**Economic and Social Council**Distr.: General
25 February 2013

Economic Commission for Europe**Inland Transport Committee****World Forum for Harmonization of Vehicle Regulations****Working Party on Passive Safety****Fifty-third session**

Regulation No. 16 (Safety-belts)**Proposal for Supplement 5 to the 06 series of amendments****Submitted by the expert from Sweden***

Paragraph 8.1.8., amend to read:

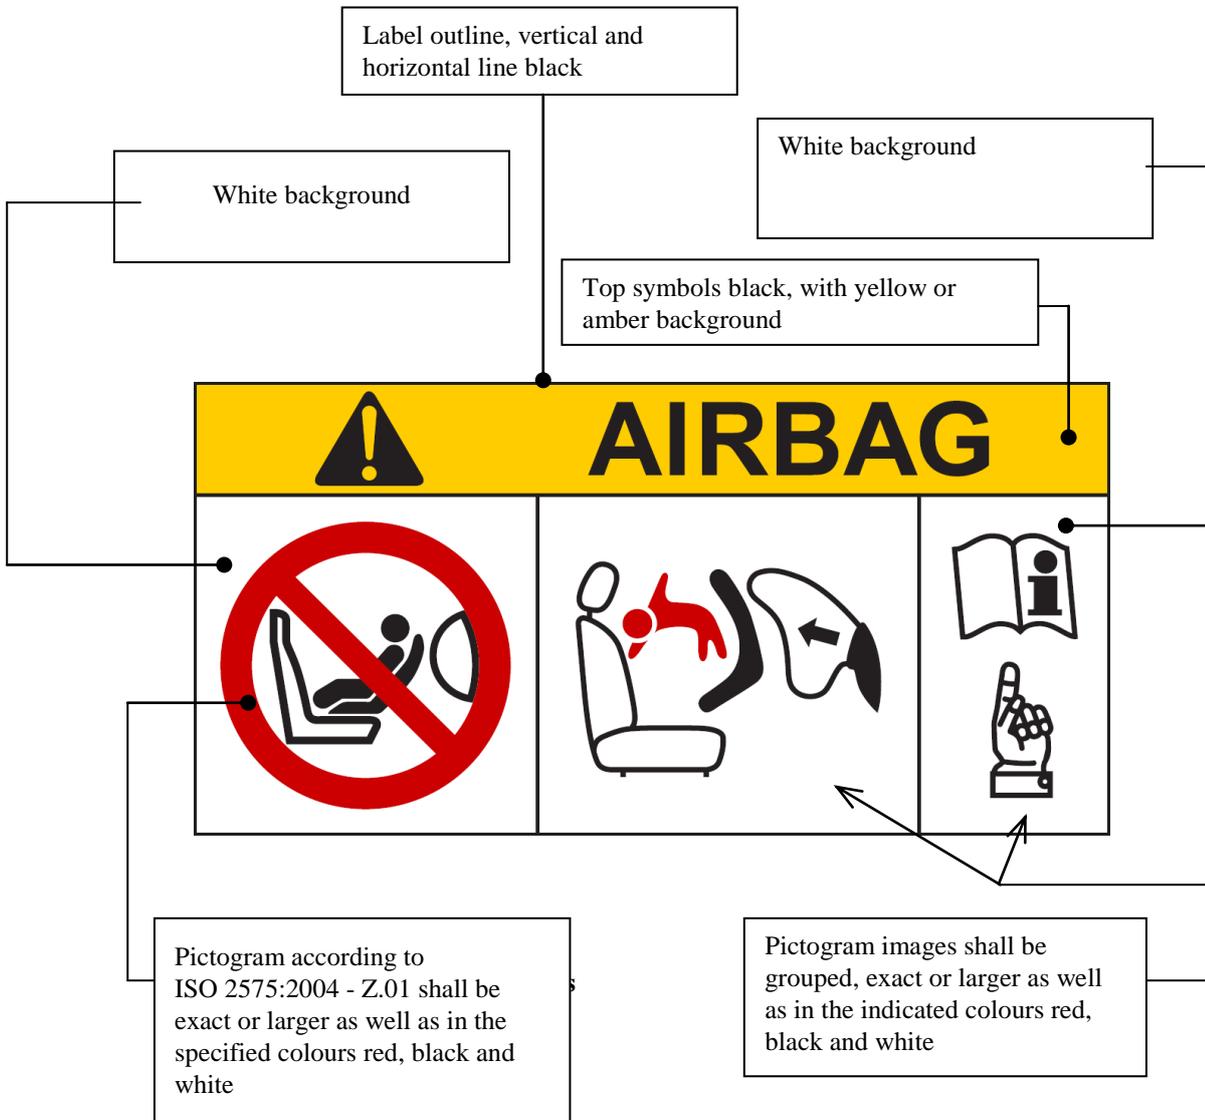
"8.1.8. ~~With the exception of the case covered by paragraph 8.1.9, Every~~ passenger seating position which is fitted with ~~an~~ **a frontal protection** airbag shall be provided with a warning against the use of a rearward-facing child restraint in that seating position. ~~The warning label, in the form of a pictogram which may include explanatory text, shall be durably affixed and located such that it is easily visible in front of a person about to install a rearward facing child restraint on the seat in question. An example of a possible design of a pictogram is shown in Figure 1. A permanent reference should be visible at all times, in case the warning is not visible when the door is closed. As a minimum, this information shall consist of a label containing clear warning pictograms as indicated below:~~

The overall dimensions shall be at least 120 x 60 mm or the equivalent area.

The label shown above may be adapted in such a way that the layout differs from the example above; however, the content shall meet the above prescriptions."
